Item Name: Replacement Skidtube, Low & High Gear with Standard Wearplates Fits LH or RH

DRAWING NO. D2650	TITLE 206/407 SKIDTUBE ASSEMBLIES	REV. F	DART AEROSPACE LTD ENGINEERING ORDER		D.E.O. NO. D2650-F-1	SHEET NO. SHEET 1 OF 1	SCALE NTS
DRAWN <i>[Signature]</i>	CHECKED A.P.	MFG. APPR. <i>[Signature]</i>	APPROVED <i>[Signature]</i>		DE APPR. <i>[Signature]</i>		
DATE 12.10.12	DATE 12.10.22	DATE 12.10.22	DATE 12.10.22		DATE 12.10.22

CHANGE C'BORED WELDED CROSSBOLT SPACERS TO SWAGED SPACERS

DETAIL B

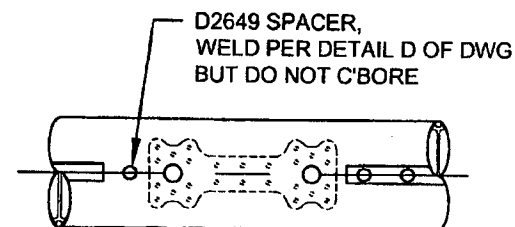
C'BORED HOLES ARE **NOW SWAGED** PER DETAIL G BELOW. FOR THE Ø0.375 HOLE THAT IS NOT C'BORED, WELD PER DETAIL D OF DWG (SEE AMENDED DETAIL B FOR REFERENCE).

AMENDMENT TO DETAIL B
NOT TO SCALE

DETAIL G

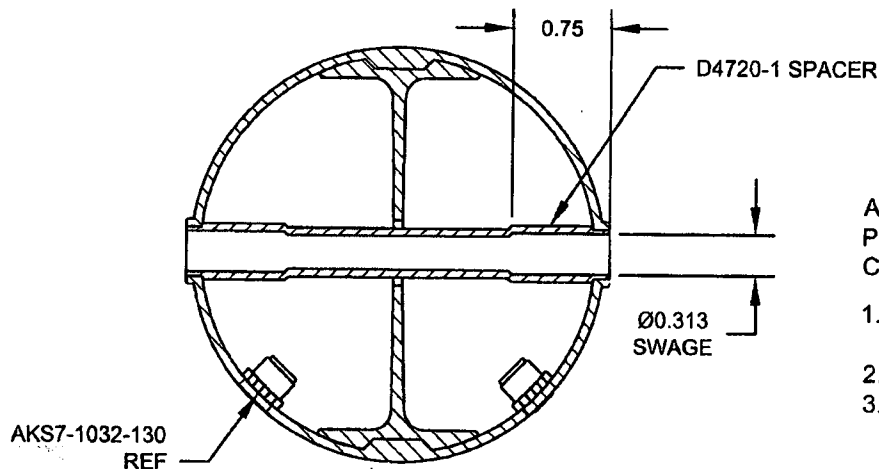
ADD DETAIL G BELOW, WHICH IS THE SAME SECTION VIEW AS DETAIL D OF DWG.
